**Re: W0231-01, Proposed Fingal Landfill**

## ***Objections to Waste Licence Proposed Decision***

# Objections to Proposed Decision for Waste Licence Reg. No. W0231-01

Figure 1: Typical Landfill Gas Production From a Municipal Landfill

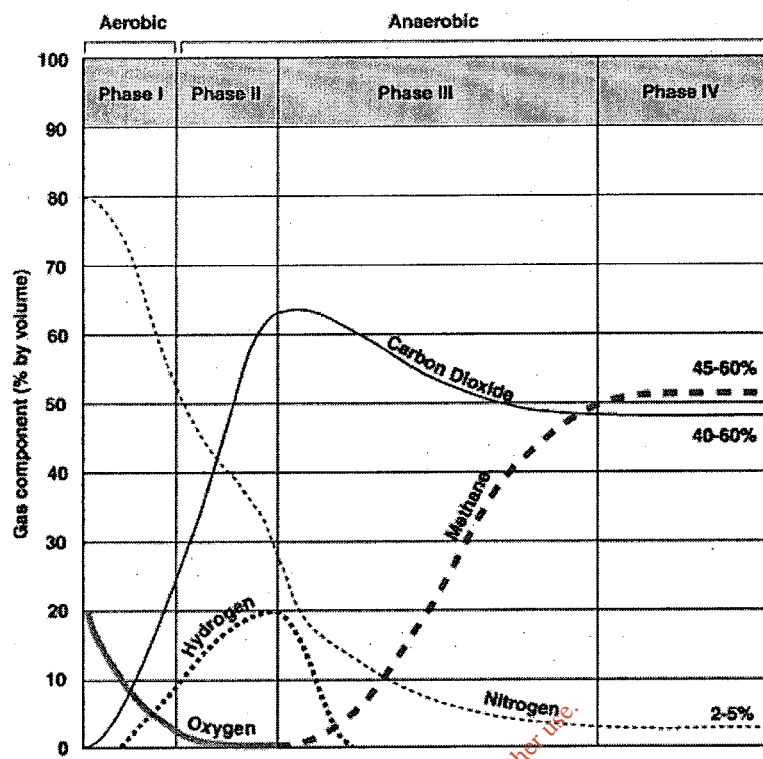
It is requested that the Agency consider amending the wording of Condition 6.4.4. It states:

*In order to minimise release of untreated landfill gas, the landfill gas flare shall be capable of operating with a gas support fuel (e.g. natural gas) to allow effective treatment of landfill gas in the event that the landfill gas itself cannot support combustion. Alternative appropriate techniques may be employed with the written prior approval of the Agency.*

Natural gas can be used in two ways to supplement the flare operation:

- As a primary fuel to supplement methane in landfill gas **burner** when concentrations fall below 25% v/v
- As a supplement to facilitate **pilot** ignition when concentrations fall below 25% v/v.

For current municipal waste streams with a high organic content, low methane concentrations will have most impact during Phases I and II (refer to diagram below) during initial filling, and subsequent to Phase IV in the restoration and aftercare period. Furthermore if organic content reduces as a result of waste being pre treated prior to disposal then this may be a significant problem during the transition phase if the landfill is degrading under anaerobic conditions. This means that a supplemental fuel may need to be used to operate enclosed flares under the low methane concentrations for many years. The use of natural gas to supplement burner operation flares however is to be avoided, and should not be obligatory in the context of the licence. It makes little sense environmentally to use large amounts of fossil fuels to manage odorous compounds.

When considering the requirement to supplement the methane with another fuel to pilot the burner the flexibility would be preferred to use inline carbon filters between blower and burner with a propane supplemented ignition source and a manual override on the flare to facilitate flaring at 14% v/v. This will allow control of odours and oxidation of available  $\text{CH}_4$  above 14% albeit not at 1000°C for 0.3 seconds. Unfortunately it will not be possible to implement this policy under condition 6.4.3 which states "Flares shall be operated to ensure a burn chamber residence time of minimum 0.3 sec and burn temperature of minimum 1000°C."

In addition a variety of landfill gas flare sizes, and number of flares, will be utilised during the lifetime of the site and will accommodate turn-down ratios to allow destruction of low levels of landfill gas.

It is requested that this condition be changed to the following:

*In order to minimize release of untreated landfill gas, the landfill gas flare shall employ appropriate technologies to mitigate the impact of odours subject to the written prior approval of the Agency.*
